MODIFICATION REQUEST:

***Blocks 3B, 3C & 10, Central Park
26 Broadway, Chippendale
(former Carlton United Brewery site)***

MP 11_0090 MOD 1

Director-General's
Environmental Assessment Report
Section 75W of the
Environmental Planning and Assessment Act 1979

Figure 2: Comparison of Approved and Proposed Building Envelopes on Blocks 3B & 3C (Source: Modification Request) (approved building envelope shown outlined in red)

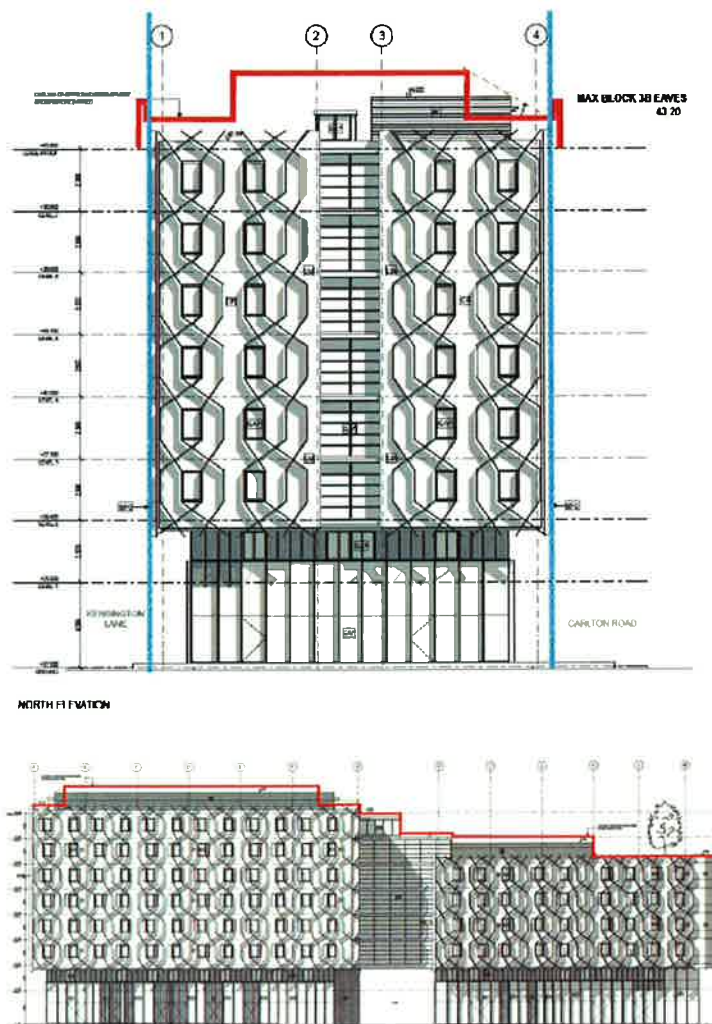
The proposed modifications would result in an overall reduction in the height of the buildings on all three blocks, as well as minor modifications to the approved building envelopes. The proposed modified building envelopes would result in some breaches of the approved building envelopes, however, the proposed modification would remain compliant with the maximum building heights and building envelopes approved by the Concept Plan (see **Table 3 and Figures 2 & 3**). The proposed modifications are therefore acceptable in this regard.
